SERVICE BULLETIN

No. 707

Piper Aircraft Corporation

Subject: PA-31-350 Chieftain Takeoff Flaps

42334

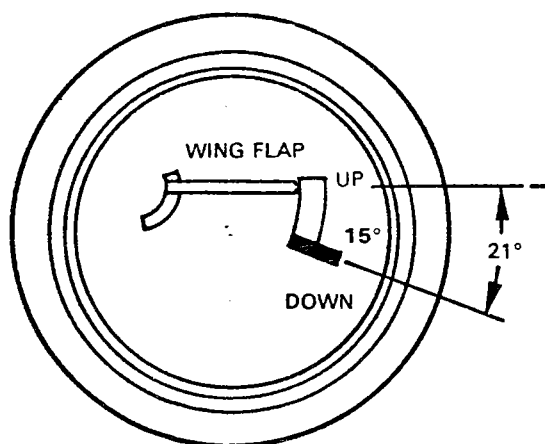
- a. 42334-00, 55564-00, 55567-00 and 55650-00 indicators must have 1/16" by 1/4" radial line placed at the end of the first white arc (15°).
 - b. 55991-05 indicators must have a 1/16" by 1/4" radial line across the white arc exactly in the middle of the complete white arc (15°).

- c. All indicators must have the legend "15°" in 1/8" letters added adjacent to the 15° radial, such that it does not interfere with any other legend.

71128 SERIES (Hickok type)

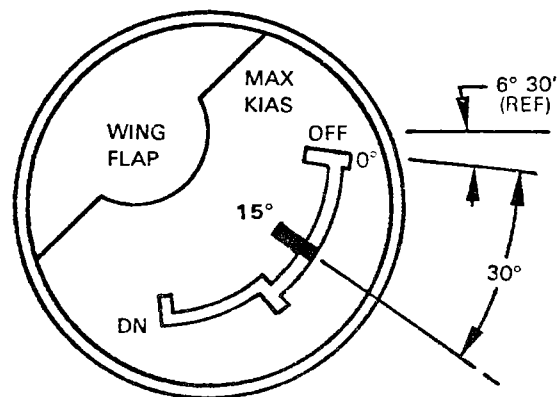
2. For the indicator of the Hickok type, Part Number 71128-04, -07, and -08, use the following instructions:
 - a. The 71128-04 and -07 indicator face has a wide arc to the 15° position with a wide radial at 15°. Mark a "15°" legend in 1/8" letters adjacent to the 15° radial but in such a position that it does not interfere with any other legend.

- b. The 71128-08 indicator face has to have a 1/16" wide x 1/4" long radial line placed across the white arc 30° down from the top of the arc and a "15°" legend in white letters must be placed adjacent to the 15° radial but in such a position that it does not interfere with any other legend.
